Final report for OPTA

Model implementation
document

31 August 2006

Our ref: 261-243

Exhibit 1:
Active mobile subscribers
[Source: Operator forecasts, Analysys]

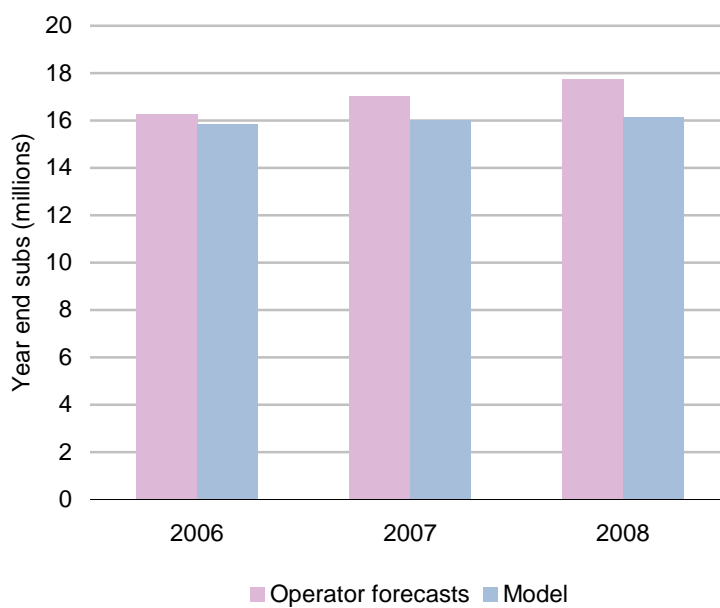
12) It should be clarified whether the volume forecast of the model is internally consistent with the sum of five/four operators' own forecasts, as supplied by the operators.

The draft model released to IG members contained a forecast that had not been verified against operators' own forecasts, since not all forecast data had been received by that point. We can now confirm that the model's forecast appears **conservative** compared to the sum of operators' own forecasts. A comparison of active mobile subscribers is shown in Exhibit 1.

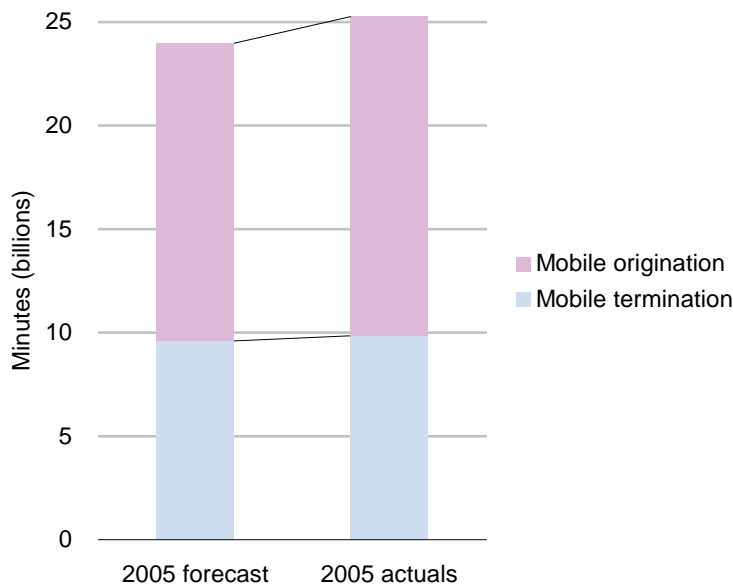
13) *The proportion of minutes that are incoming calls declines over time – the basis for this assumption is unclear.*

We note that this decline is relatively small, from 39.6% to 38.3%. Further discussion on this aspect is presented with Statement 14 below.

Exhibit 8:

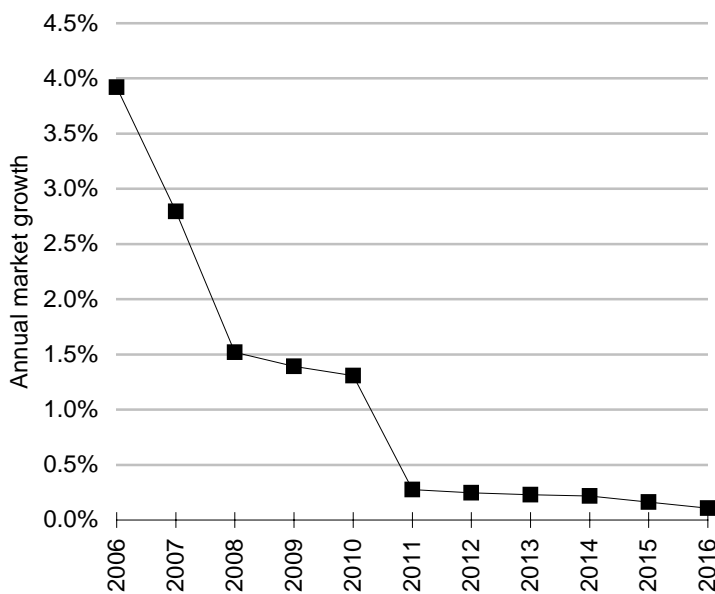
75) *The economic depreciation approach is simplistic, in that service unit costs vary only with changes in equipment unit costs. Instead, unit costs should reflect not only price trends, but the change in asset productivity (utilisation) which can be achieved at each point in time. In effect, existing networks will need to write down their own asset values to allow for both the fact that historical equipment prices differ from current price, and also the fact that the historical asset utilisation rates were lower than those that could be achieved by the hypothetical new entrant going forward. This amounts to modelling successive generations of new entrants in each year and solving previous entrants' cost recovery requirements (i.e. that of the existing players) in reverse. This effect can be included in the model by tilting the cost recovery profile as a function of growing market demand, where the growth in market demand is factored by a cost-volume relationship between 1.0 and 0.0 (estimated at 0.5, but which can be calibrated)⁷. Another IG member suggests that the applied economic depreciation method does not allow costs incurred in the past (when asset utilisations were low) to be recovered during current periods (when asset utilisations are higher).*

Finally, we note that because the modelled hypothetical new entrant’s volumes grow at the same (average) rate as actual operators have in the past, the same costs of similarly lower utilisation in the early years are recovered across from all units of demand occurring during the lifetime of the network.

Exhibit 9:

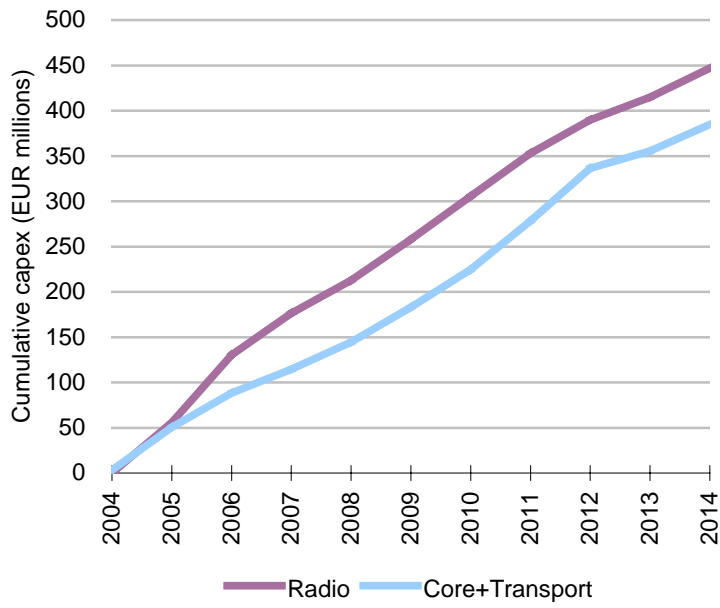
93) The expenditure for Core+Transmission should be equal to the expenditure for Radio, since this is already the case for [operator]

Examination of the final model reveals that these two expenditure categories are similar for a PGSM operator of approximately ten years' maturity (see Exhibit 9). For a DCS operator, radio costs are notably higher than PGSM costs, particularly in the early years. In this comparison it is worth noting that the modelled radio network has been increased in area coverage (to 99.1% area) and increased in quality (compared to less-than-average quality operators).
